Work Order ID 142256

647.0113
B142256
REV. A1

Item Name: Strut Doubler

APICAL INDUSTRIES, INC.	ENGINEERING CHANGE NOTICE NO.		03985		SHEET 1 OF 2	
	DWG NO.	647.0100	REV:	A	PREPARED BY	J. BECKER
	DATE: 7/15/13		EFFECT ON DWG ☐ INC. ☒ UNINC.			
	DWG TITLE: SHEET METAL					
TRANSACTION CODES (TC): A-ADD R-REVISE C-CREATE D-DELETE	APPROVED BY:	ENGR 	MFG 	QC 	EFF. NEXT ORDER	
REASON: REVISED NOTE 2. ADDED 647.0117

DWG NO. 647.0100

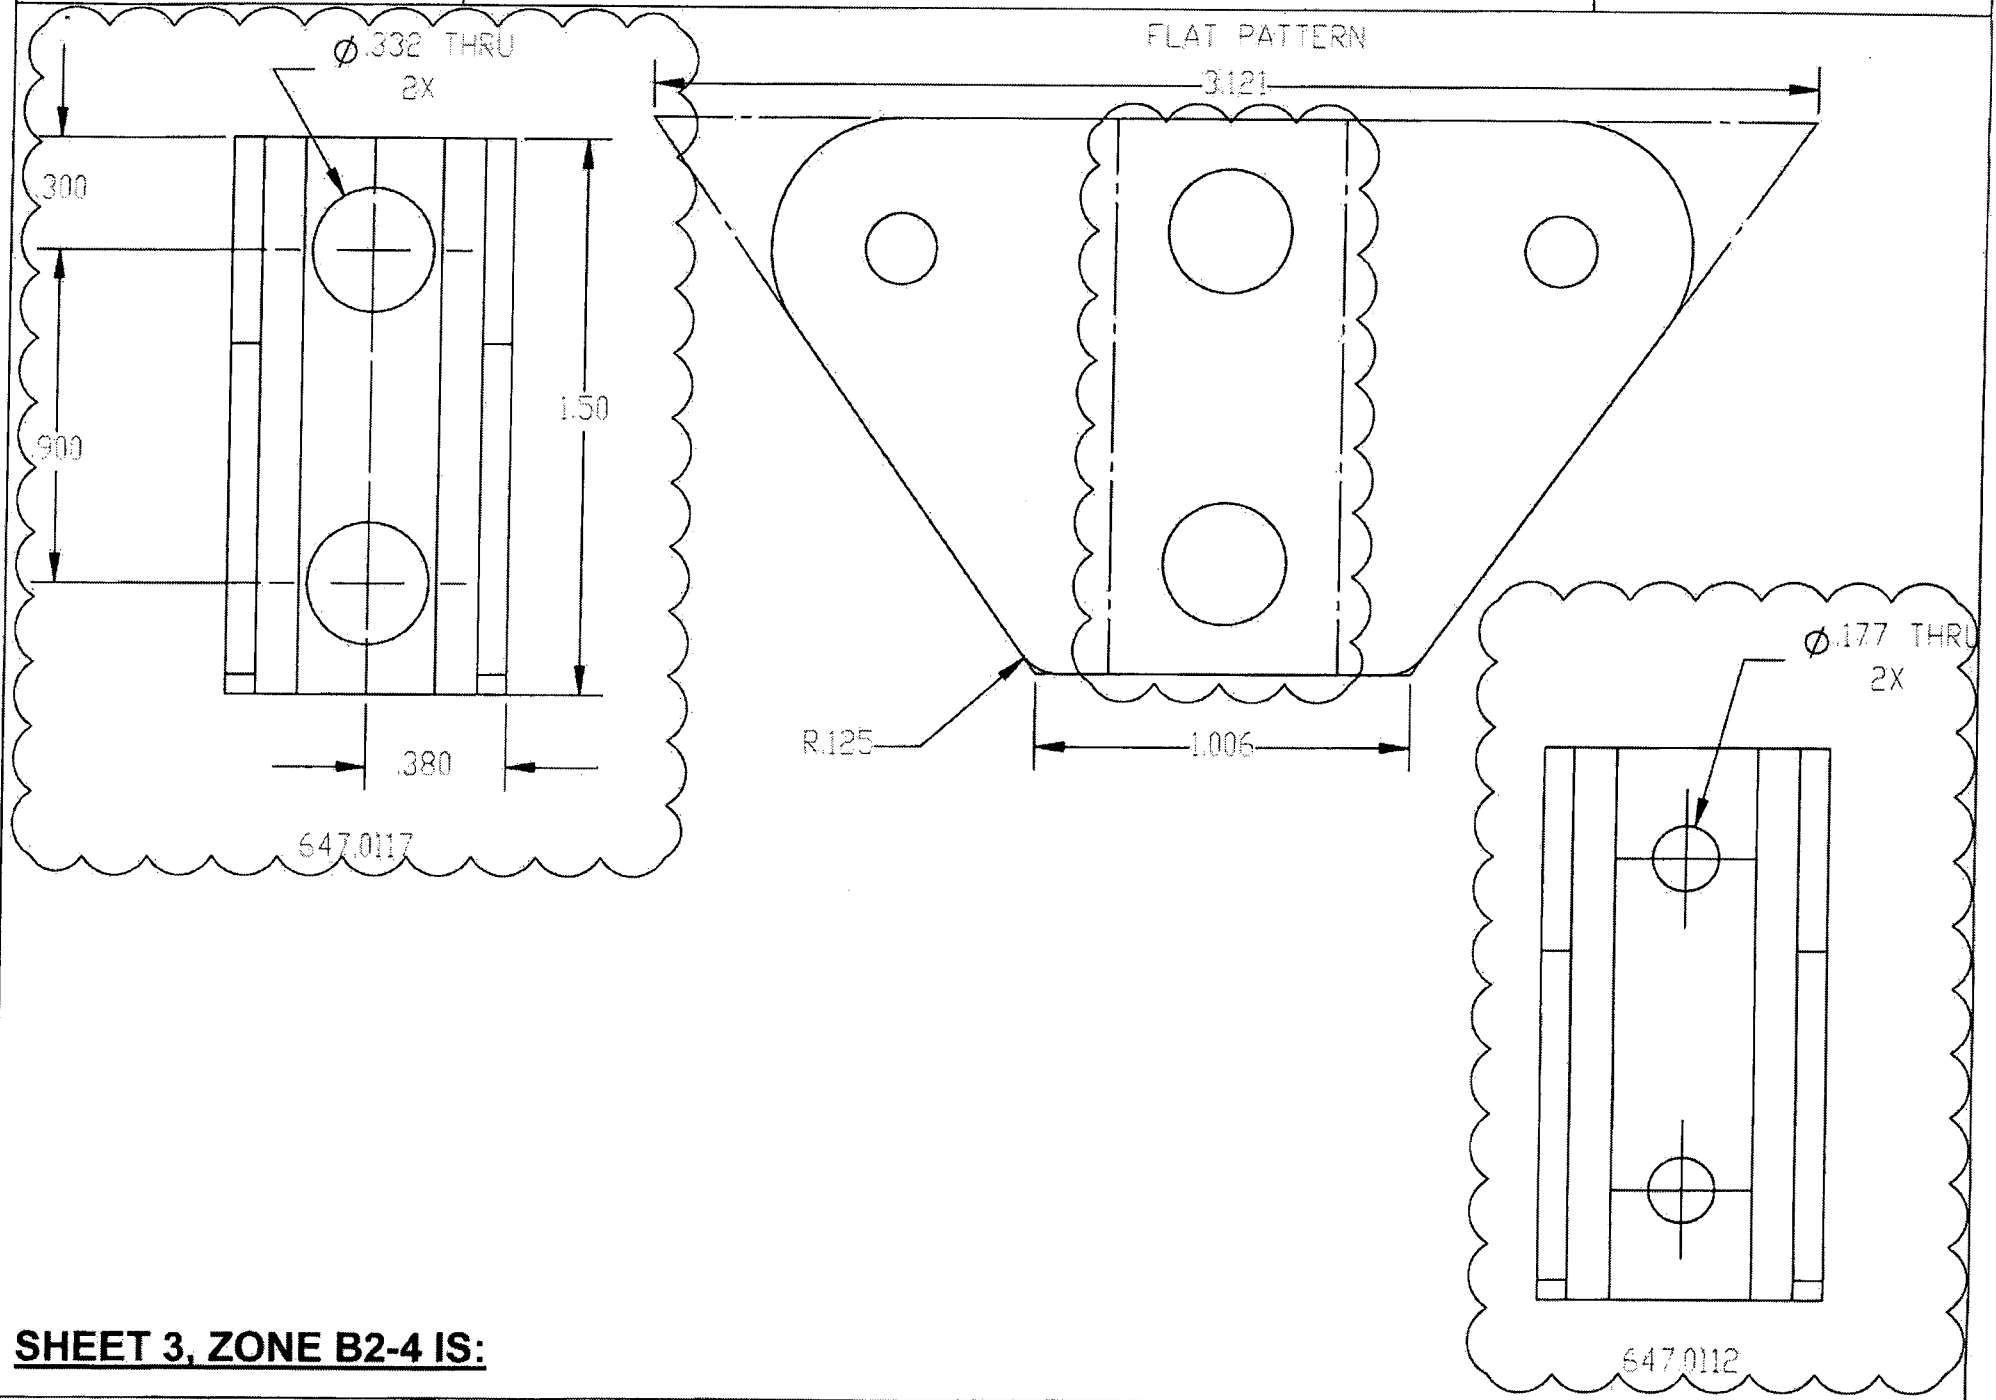
REASON: REVISED NOTE 2. ADDED 647.0117

- 1 MATERIAL: ALUMINUM 2024-T3 PER AMS-QQ-A-250/4.
- 2 FINISH: IAW MPP-172 ANODIZE IAW SECTION 2.1,
PRETREATMENT IAW SECTION 3.1
AND PRIMER IAW SECTION 4.1.
3. DEBURR AND BREAK ALL SHARP EDGES.
4. IDENTIFY IAW MPP-120.
- 5 MATERIAL: 304 SS IAW AMS 5643.
- 6 FINISH: PRIME IAW MIL-P-23377J TYPE I CLASS N.
- 7 OTHER DIMENSIONS SAME AS 647.0112.

SHEET 1, ZONE D1 IS:
